Corrected schematics: June 1st, 2009

for details, refer to the "C-One core development" manual by Peter Wendrich

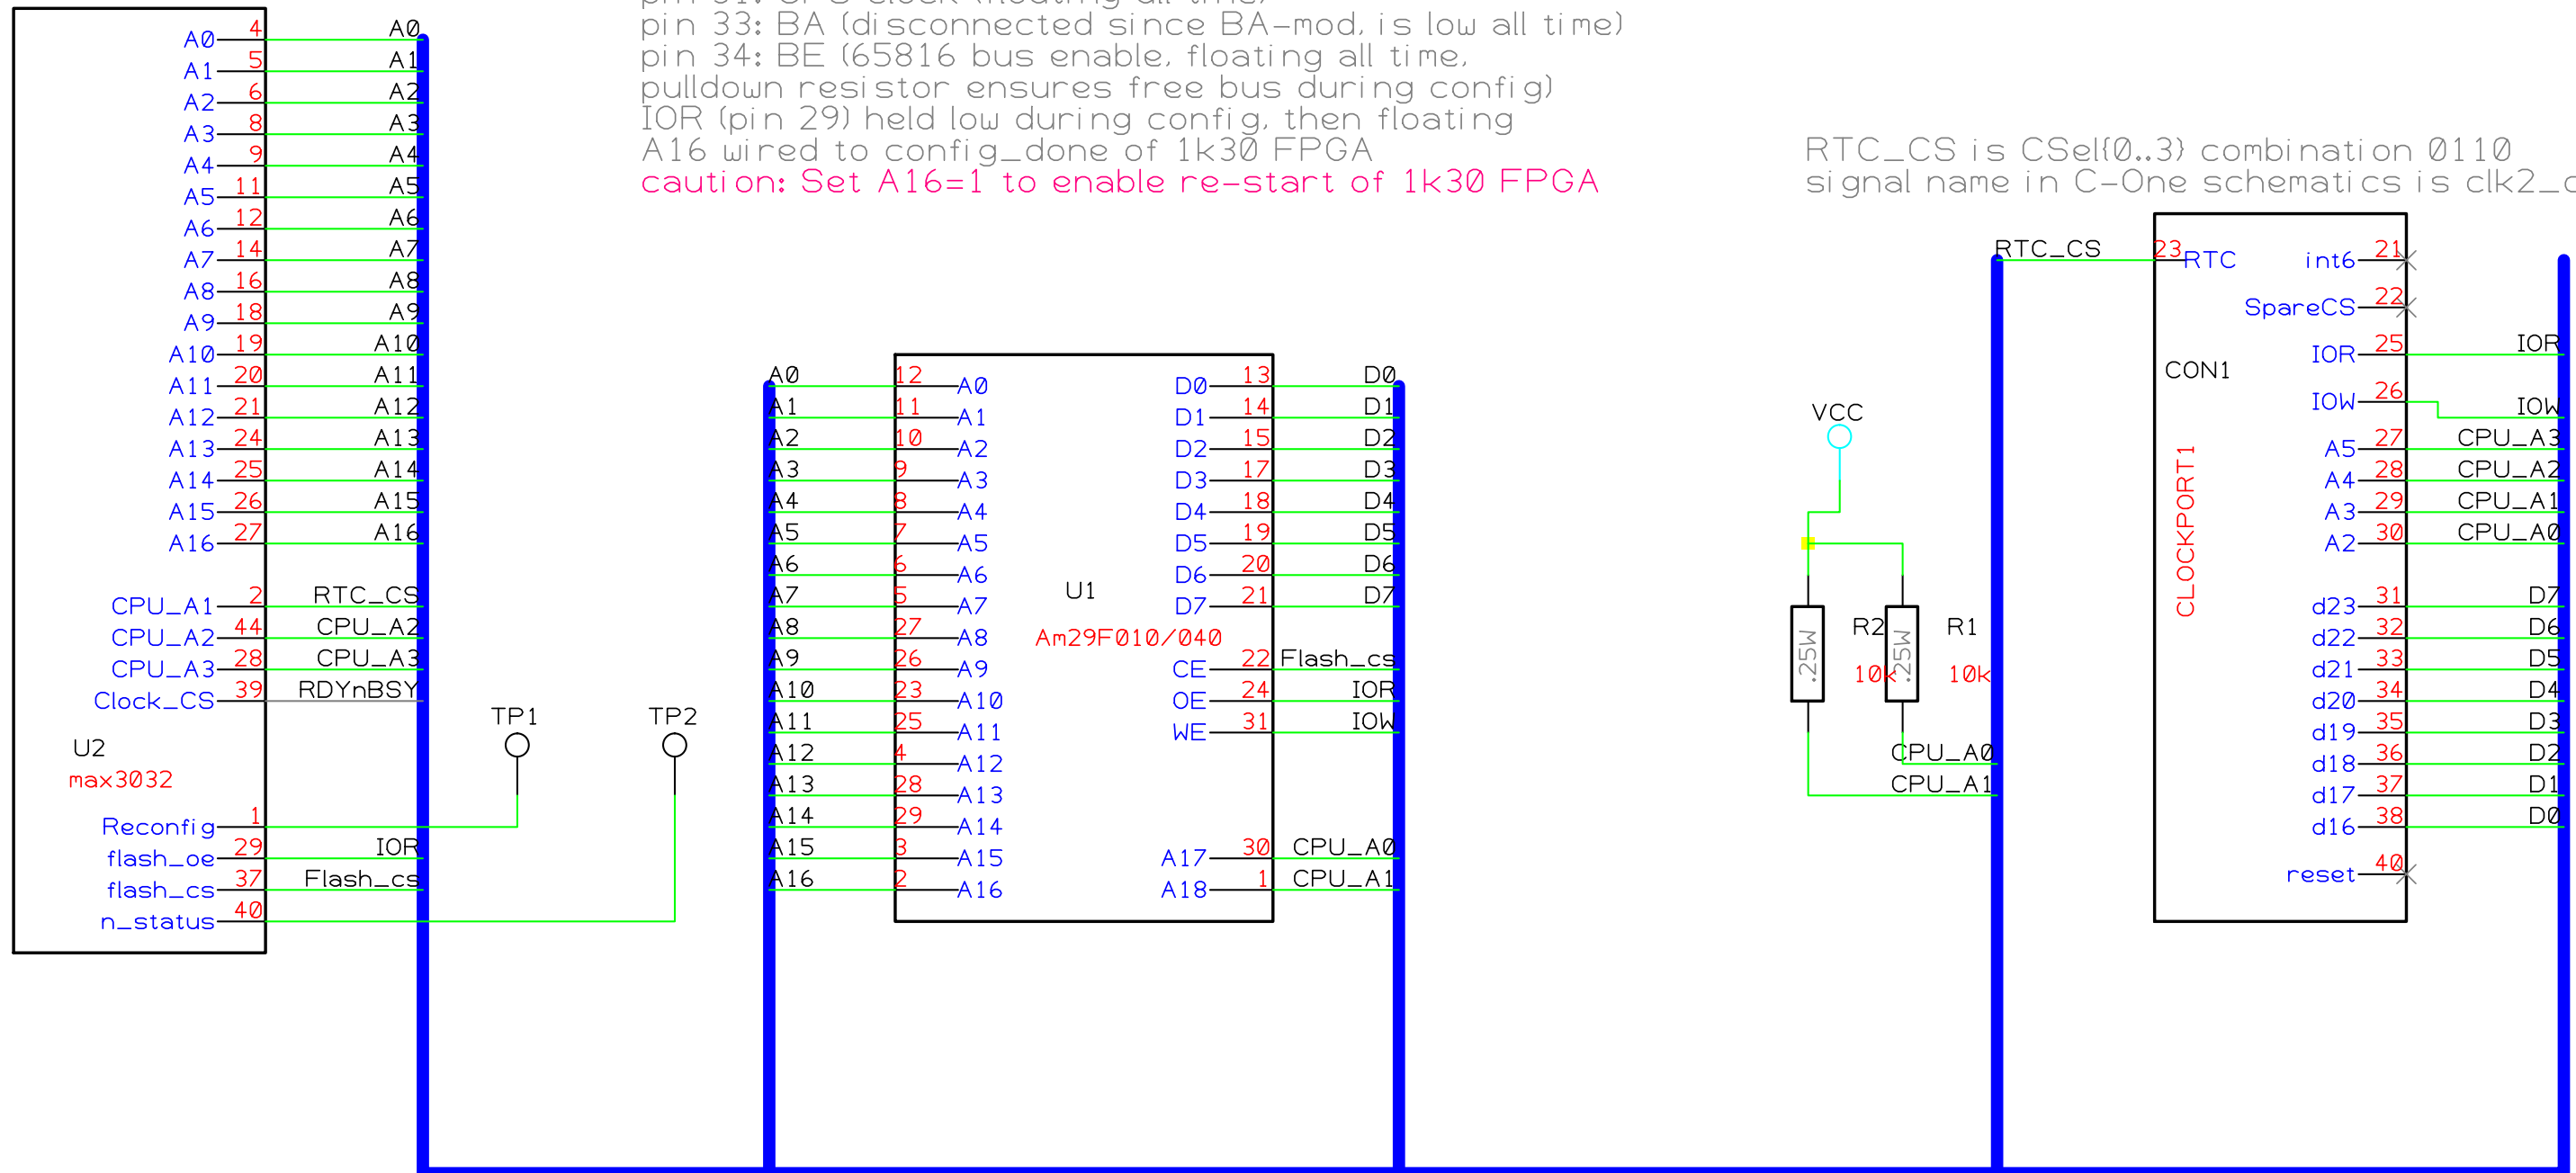
caution: Chip symbol has wrong signal names, refer to connected signal names only!

more CPLD signals:  
 pin 41: write pulse for FPGA config  
 pin 43: 2MHz clock  
 pin 31: CPU clock (floating all time)  
 pin 33: BA (disconnected since BA-mod, is low all time)  
 pin 34: BE (65816 bus enable, floating all time, pulldown resistor ensures free bus during config)  
 IOR (pin 29) held low during config, then floating  
 A16 wired to config\_done of 1k30 FPGA  
 caution: Set A16=1 to enable re-start of 1k30 FPGA

RTC\_CS is CSel{0..3} combination 0110  
 signal name in C-One schematics is clk2\_cs

TP1 soldered to diodes right next to instant-on board  
 TP2 soldered to nStatus signal on board (blue wire)  
 RDYnBSY signal becomes DMA signal of expansion after config  
 CPLD ignores RDYnBSY while doing config (writes are timed only)  
 config data is taken from address 0x60000 of flash chip

CPLD waits for nConfig signal, then starts counting through full 64k of flash on power-up, pulsing Flash\_CS and pin 41 for every byte, then enters user mode, leaving address counter at A[16..0]=[1000000000000]  
 user mode gives flash access through bottleneck.  
 set address with reset/count/shift-left, then access flash address
